**STAFF REPORT 04-15-2020 REGULAR MEETING**

**APPLICATION NUMBER: 20-6687**

**ADDRESS: 961 BURNS AVENUE**

**SCOPE: REPLACE EXISTING ALUMINUM WINDOWS WITH NEW WOOD WINDOWS**

Original windows depicting 2 sashes:

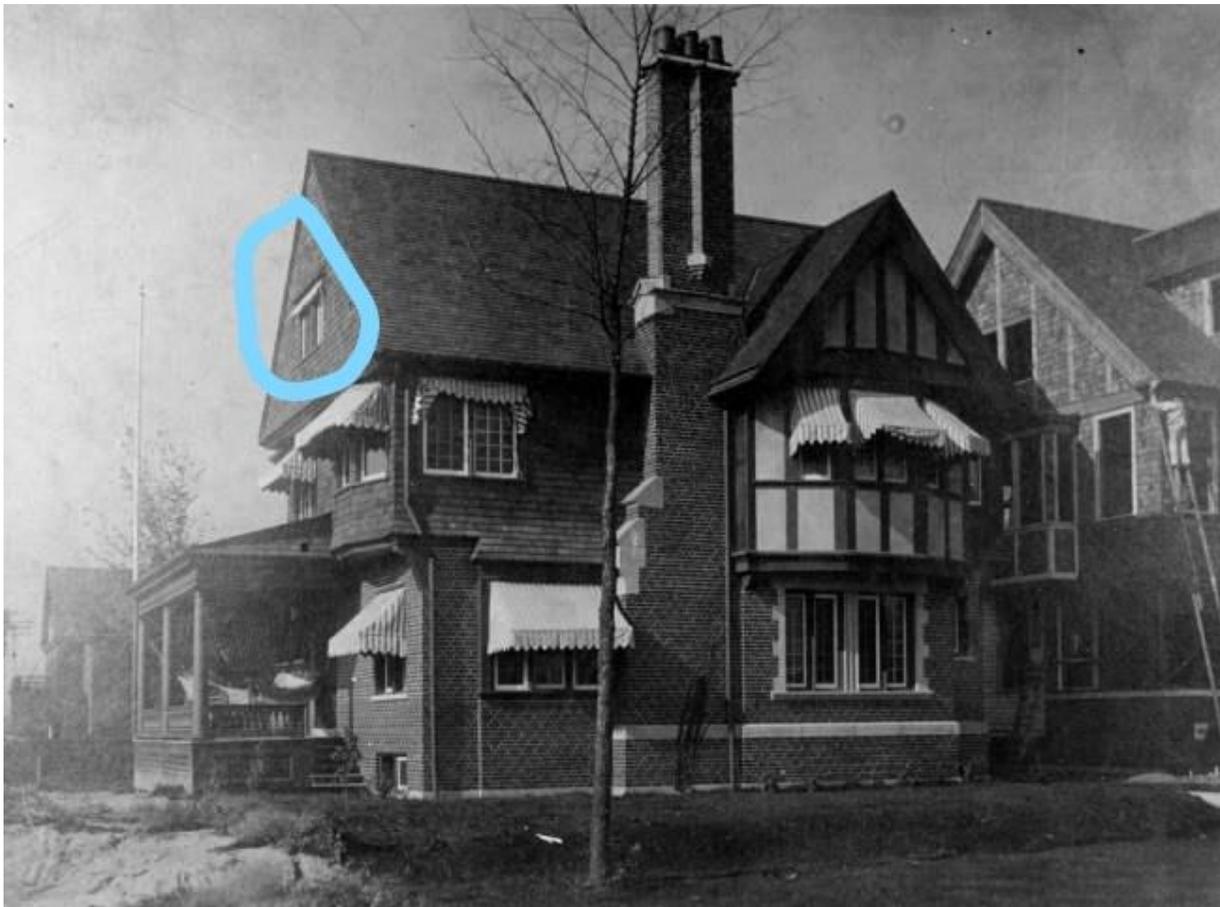
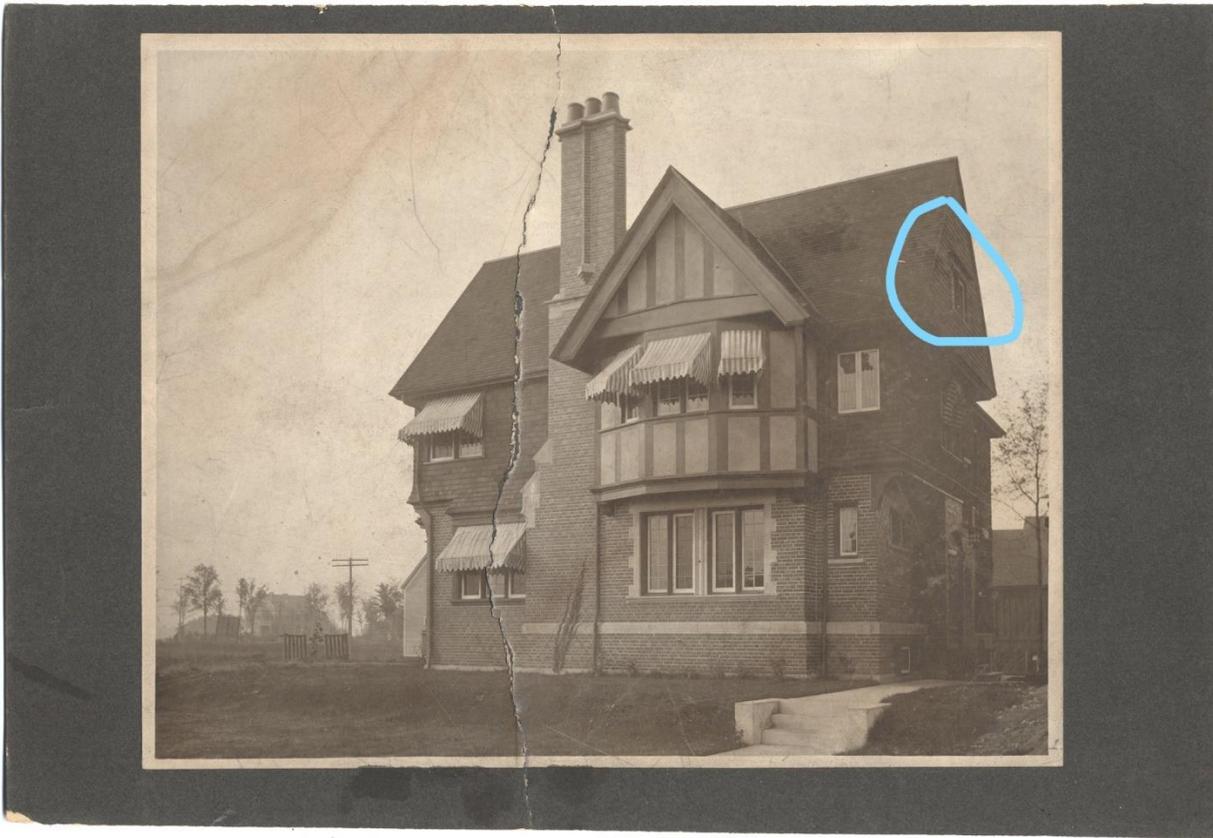
- The **photograph** which the applicant is using to show the original inswing windows is of a set of windows on the second floor, not the third floor. Additionally, upon looking at the historic photos provided by the applicant, the third floor opening in the gable end at the front of the house is not present which means it was added at a later date and is not original.
- At the time of designation, the house included the (3) mullied windows in each gable end.
- It is not apparent that the configuration of the existing openings was at any point two sashes rather than three.

- The in-swinging wood casement replacement windows are to match the existing configuration of three divided lite sashes to match the current configuration – (3) eight-lite in-swinging wood casements divided by two mullions as currently configured.
